Access Compliance Report

Public Rights-of-Way

Intersection ID: N/A	Main Street: STEEL_CREEK_RD	Cross Street: ENTRANCE_DR	Location: W
ADA ID: 07F8754C6D37	Ramp Type: PerpDiag	Initial Pass/Fail: Fail	Overall Compliance: No
		Severity Score: 10

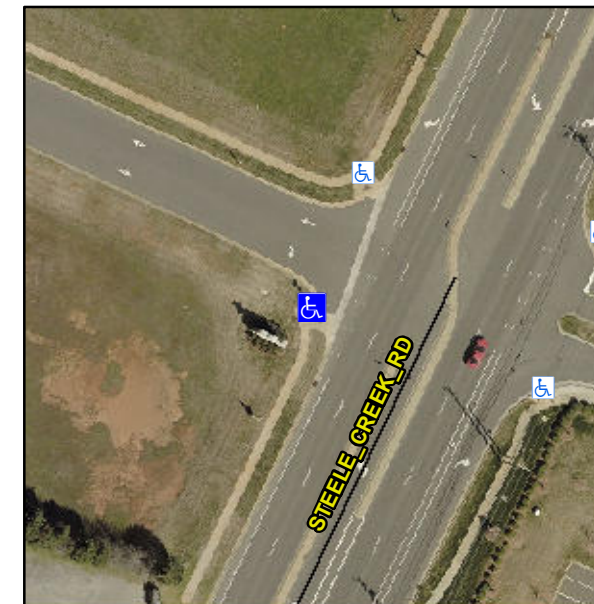
R304.5.1, R304.5.3

Compliance	Description	Data	Compliance	Description	Data
N/A	Ramp Length (in)	96.0	Yes	Ramp Slope (%)	8.0
No	Ramp Width (in)	47.0	No	Ramp XSlope (%)	2.9
N/A	Flare Type LT	N/A	N/A	Flare Type RT	N/A
N/A	Flare Slope LT (%)	N/A	N/A	Flare Slope RT (%)	N/A
N/A	Flare Traversable LT?	N/A	N/A	Flare Traversable RT?	N/A
N/A	Landing Length (in)	N/A	N/A	DWS Provided?	N/A
N/A	Landing Width (in)	N/A	N/A	DWS Contrast?	N/A
N/A	Landing Slope (%)	N/A	N/A	DWS Length (in)	N/A
N/A	Landing X Slope (%)	N/A	N/A	DWS Full Width?	N/A
N/A	Landing Curb? (Y/N)	N/A	N/A	DWS Offset (in)	N/A
N/A	Shared Landing?	N/A			
N/A	Gutter Ponding?	N/A	N/A	Gutter Slope (%)	N/A
N/A	Gutter Lip Ht (in)	N/A	N/A	Gutter X Slope (%)	N/A
N/A	Painted X Walk1?	No	N/A	Painted X Walk2?	No
	X Walk 1 Direction	To E		X Walk 2 Direction	To N
N/A	X Walk 1 Width (in)	N/A	N/A	X Walk 2 Width (in)	N/A
	X Walk 1 Slope (%)	2.3		X Walk 2 Slope (%)	2.0
	X Walk 1 X Slope (%)	0.0		X Walk 2 X Slope (%)	1.0

Remove & Replace Curb Ramp With Two New Directional Ramps or Equivalent.
